**Wetlands Permitting****WP-25-15**

Construction of a 3 lot subdivision with associated common driveway and stormwater controls

### Redline Plans - page 1

**Narrative for the Implementation of E & S and Stormwater Management Measures**  
**Proposed 3.86 Acre – 3 Lot Subdivision on Route 44 – *REVISED 7-21-2025***

PLAN PREPARED FOR CHARLES A. BROWN  
**LAND OF MARGARET REID AND REID MARTIN**  
 ROUTE 44 / BOSTON TURNPIKE MAP 22-108 COVENTRY CT.  
 SUBDIVISION PLAN

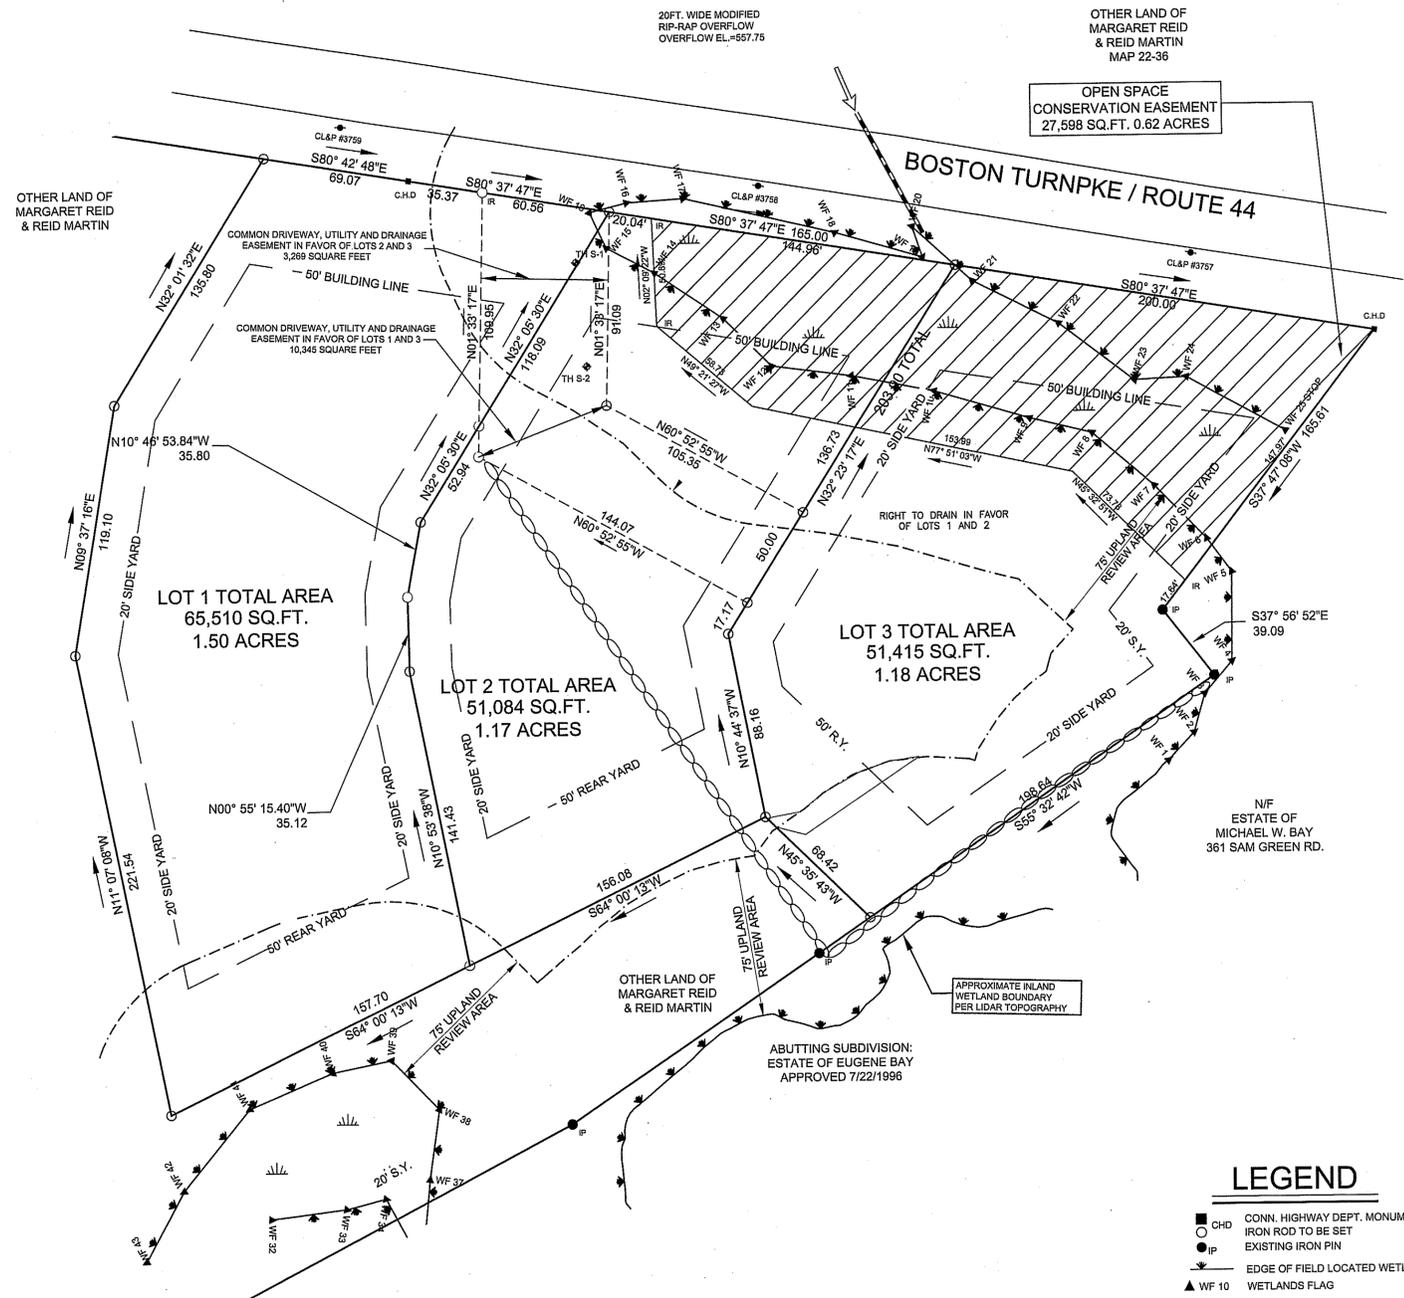
Comment- Need to show entire 19 acres.

Comment- Have wetland report prepared.

Comment- Why is a portion of the remaining land to the east of lots 1 & 2 not included in those lots?

Answer- *We will provide the free cut plan which shows wetlands for entire 19 acres.*

Answer – *This was one of John Ianni's last projects before he retired. He was willing to go back out to verify the wetland flags (which he did) and endorse the plans. However, he is retired and has firmly told us he would not prepare a report or attend any meetings. This was the same situation we were in for the application across the street and was discussed with the commission. To require a wetland report now would involve finding a new soil scientist. Let's discuss.*

Answer – *That portion needs to be included in the remaining land in order to satisfy the required ratio of units per acre for the development that is proposed for the remaining land. That portion of the remaining land is planned to be designated as open space in that development.*

PLAN PREPARED FOR CHARLES A. BROWN  
**LAND OF MARGARET REID AND REID MARTIN**  
 ROUTE 44 / BOSTON TURNPIKE MAP 22-108 COVENTRY CT.  
 GRADING / E & S PLAN

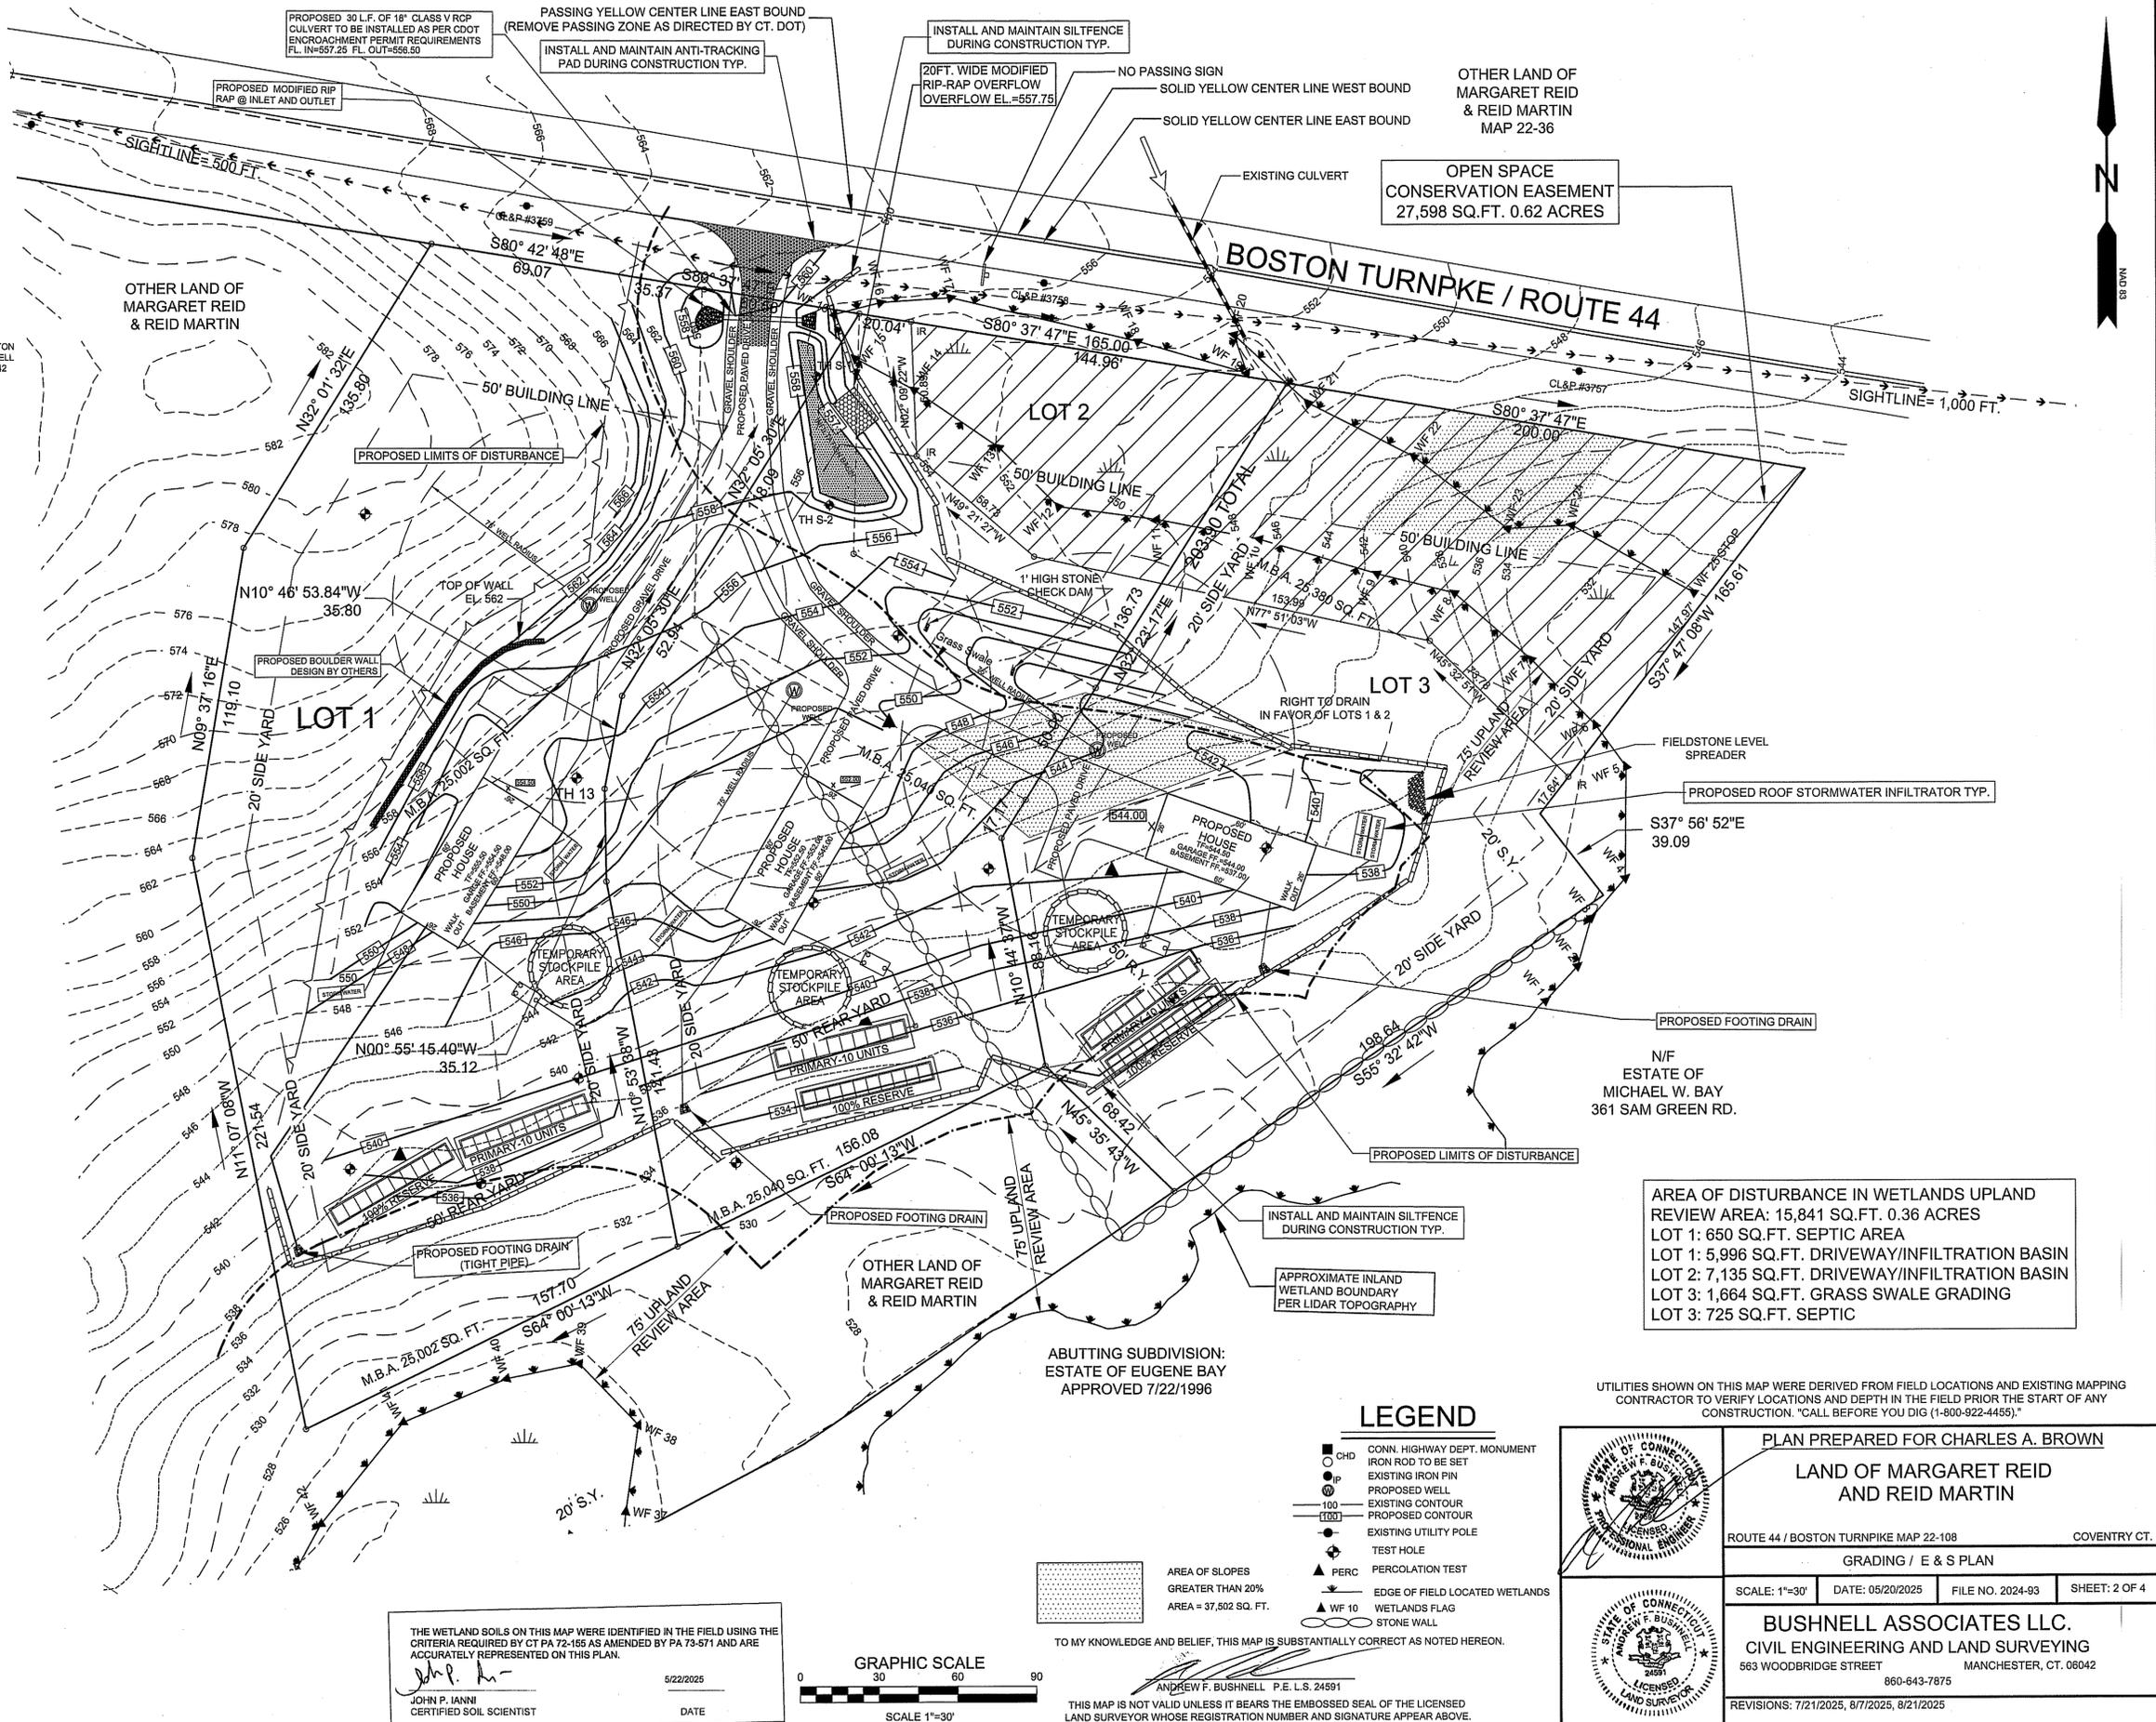
Comment – Add topo at street.

Comment – Are there any improvements that might be incorporated to improve stormwater quality?

Comment – Add Sightlines.

Comment – Plan is busy, move items to detail page.

Comment – Larger scale plan.

Comment – Have wetland scientist comment as to what direction wetlands continue in after WF#1.

Answer – *Added to plans.*

Answer – *Assume note is asking about improvements within the R.O.W.? The culvert has been re-located out of the state R.O.W.. Cannot think of any additional improvements given the space constraints to wetlands.*

Answer – *We have met on site with CDOT and will comply with CDOT sightline requirements. A note has been added that driveway will meet the CDOT standards and is subject to CDOT approval.*

Answer – *Plans have been revised to address this.*

Answer – *Plans now include a 30-scale drawing.*

Answer – *As discussed above, the further employment of John Ianni is questionable. It also may not be legal to have any soil scientist enter a neighbor's property to do physical borings. Todd's estimation of the wetland boundary seems reasonable and we also have the certainty of knowing where the wetlands exist, up to the stone wall along the Bay property line.*

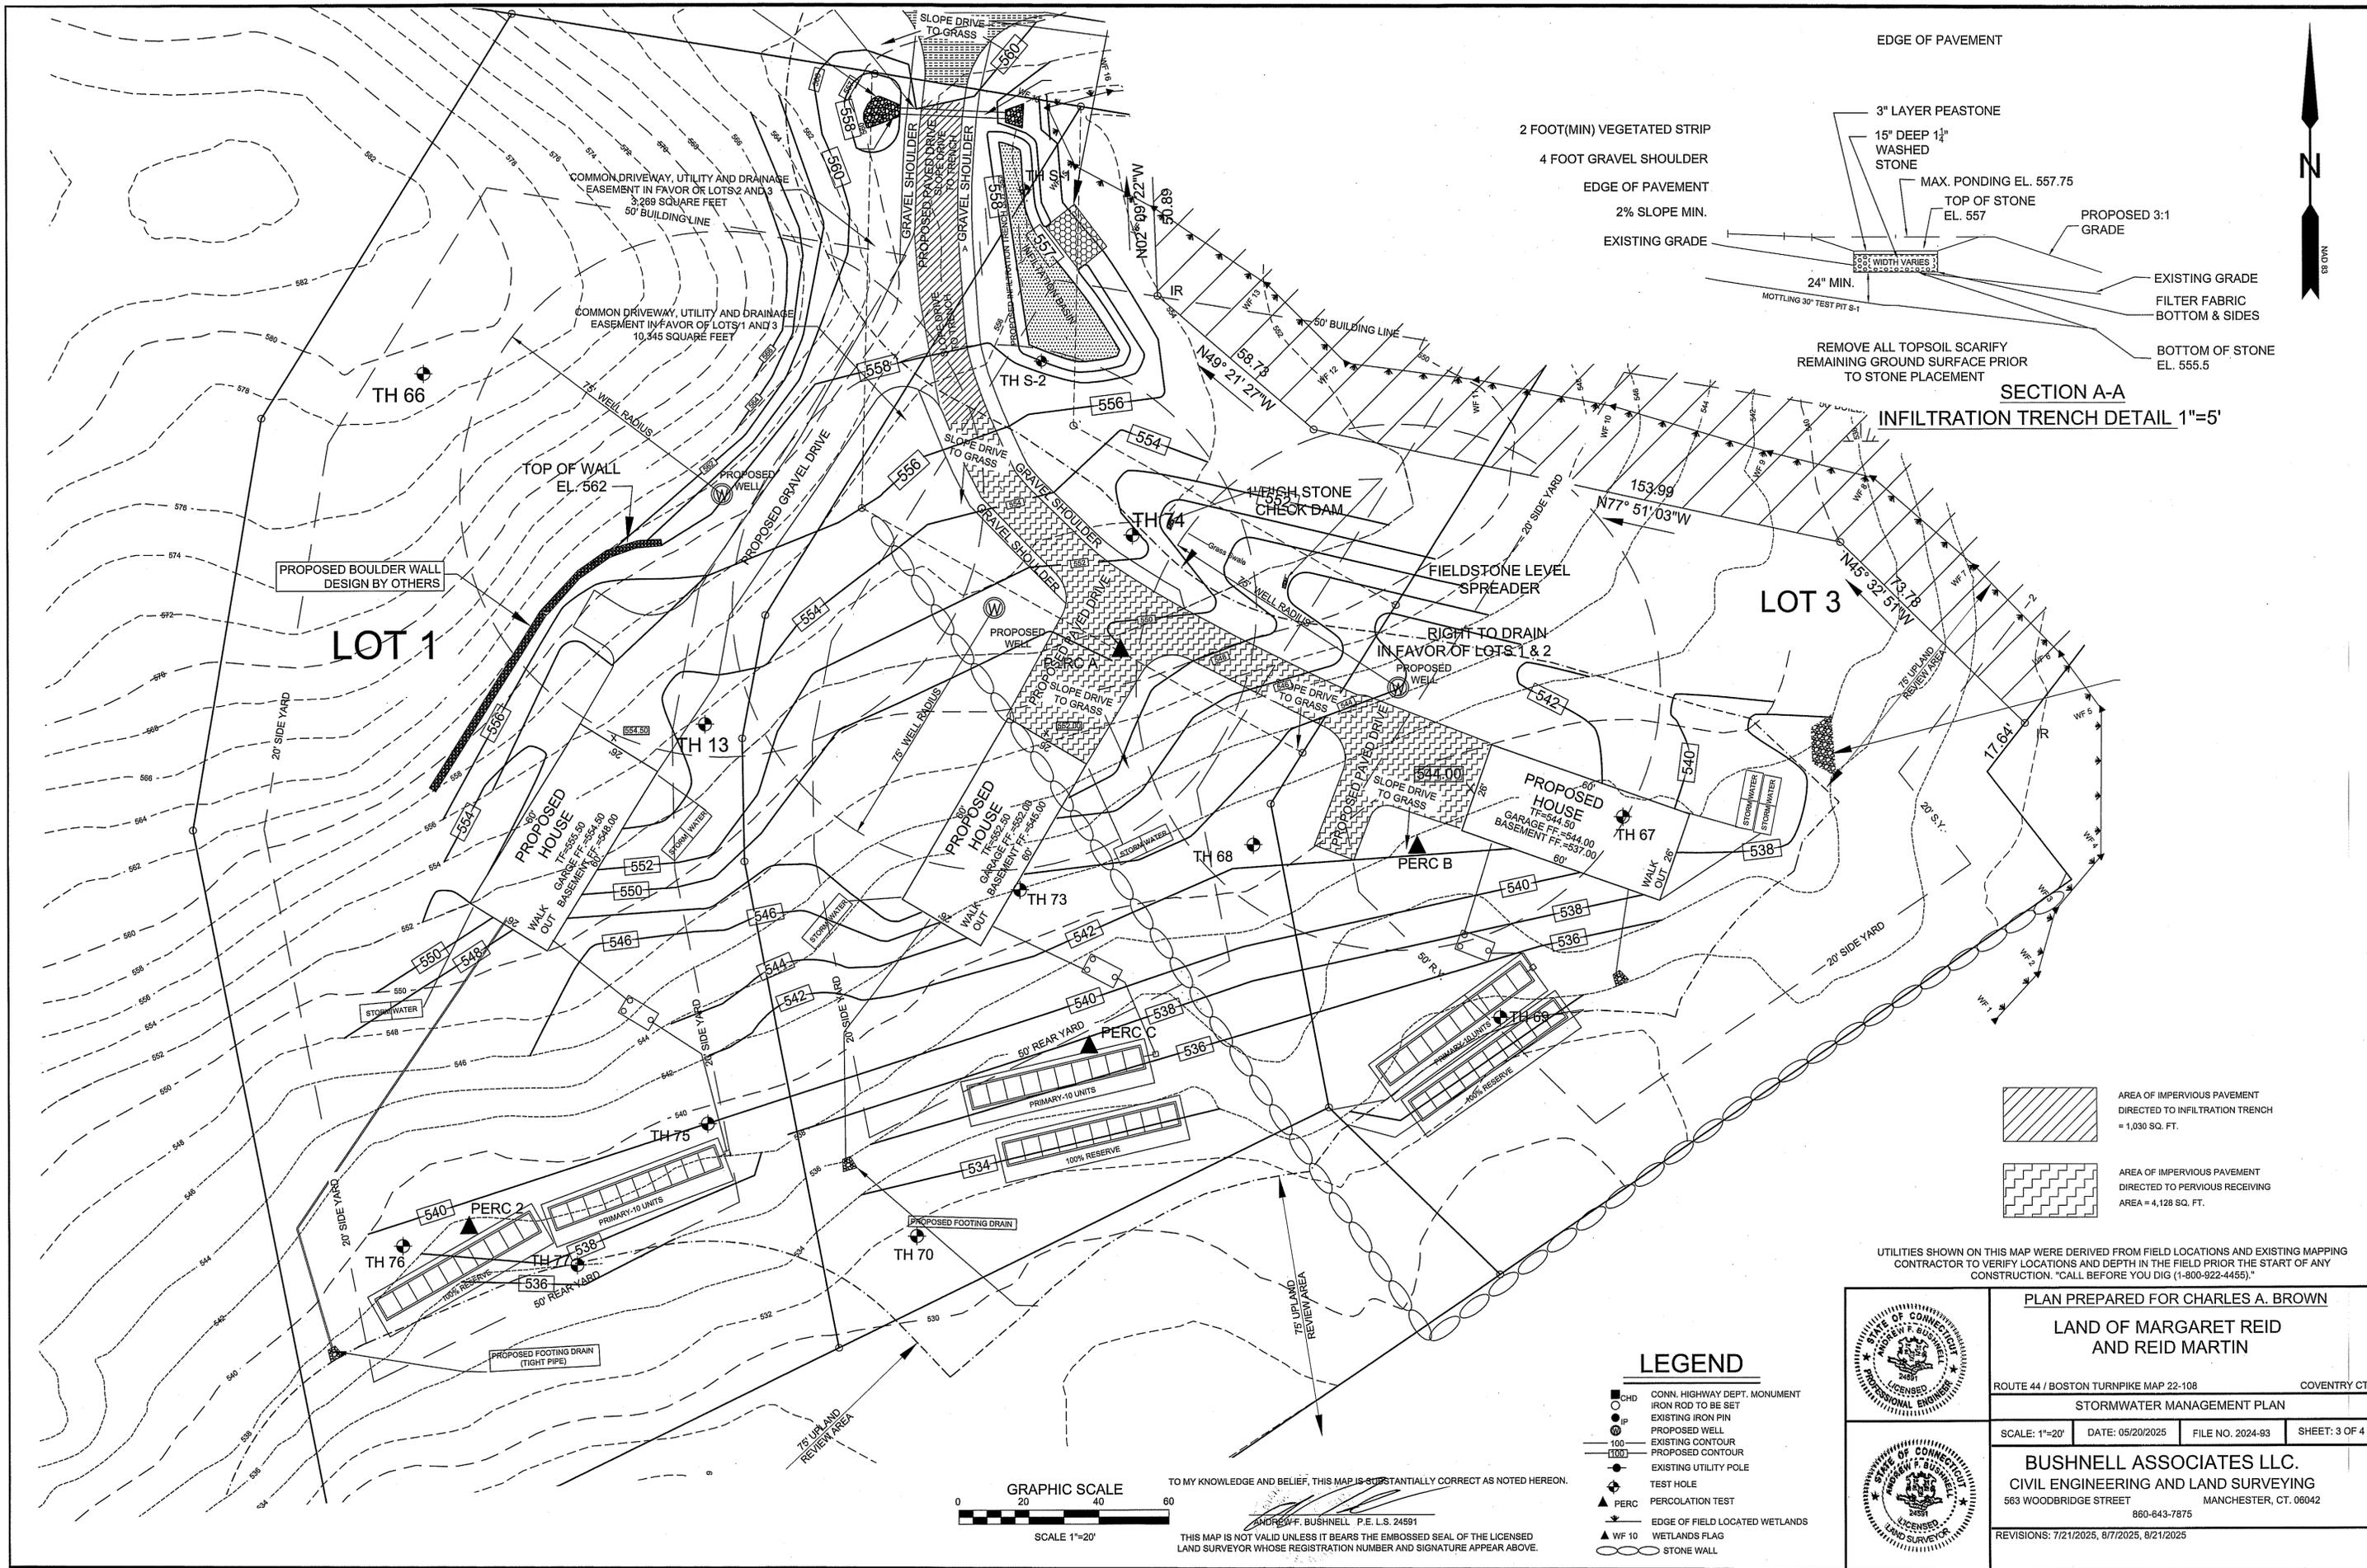
Comment – Add existing and proposed topo and culvert inverts.

Comment – Driveway is lower than infiltration trench.

Comment – Does infiltration trench overflow to swale?

Comment – Concerning the runoff path from the outlet.

Comment - Depict septic tanks, sewer lines and walkout basement notes.

Comment – Lot 2 turnout?

Comment – Consider a culvert under Lot 2 Driveway.

Comment – Will stone walls need to be salvaged?

Comment – Consider moving footing drain on Lot 2.

Comment – Why isn't the septic system on Lot 1 farther away from U.R.A.?

Comment – Why is drive to Lot 1 gravel when the others are paved?

Comment – Proposed contour 556 is missing by the turnout for Lot 1 resulting in a grade of 25%+-.

Answer – *Added to plan.*

Answer – *Elevations have been revised and contours adjusted on the plans.*

Answer – *The infiltration trench is expected to overtop along its length and function as a level spreader. The swale is not intended to be the outlet for the trench.*

Answer – *The runoff from the swale is not meant to cross the drive, rather it should exit into the vegetated buffer area behind the house on Lot 3. The grading has been revised on the plan.*

Answer – *Added to plans.*

*The driveway extension to serve lot 3 will act as a turn out for Lot 2. A 2-car garage is anticipated which will provide 4 parking spaces.*

Answer – *The grading has been revised to direct more water into yards before lot 2 driveway and to create a gutter at intersection of Lot 2 driveway and common drive.*

Answer – *Yes, see note on page 4.*

Answer – *Footing drain has been pulled back.*

Answer – *To establish that a lot is buildable, Section 4.04.04 of the zoning regulations requires a minimum buildable area of 25,000 sq ft. and the house and septic need to be shown to fit within this area. Slopes in excess of 20% cannot be included in the minimum building area. The 20% slopes are shown on page 2 and the location of the 20% slopes results in the septic being depicted where it is.*

Answer – *The common drive needs to be paved but the drives to Lots 1, 2 & 3 do not need to be paved. However, given the short length of Lot 2 and the grade to Lot 3 approaching 10% they seem more likely to be paved than not. The relatively gentle grade of the Lot 1 drive makes gravel a feasible option. Although none of the drives need to be paved, for the purpose of the stormwater calculations having the two drives paved and leaving one drive gravel seemed reasonable. The Stormwater Guidelines stress the application of L.I.D. and advocates directing driveway runoff in a sheet flow to adjacent impervious areas (disconnection). In the event the driveway to Lot 1 is eventually paved the area adjacent to the driveway is long enough and wide enough to accept the runoff and would not require a structural BMP. Disconnected impervious areas are not included in the WQV calculation so the paving of lot 1 would not impact those comps either way.*

Answer – *Contour 556 has been inserted and the proposed grades revised.*
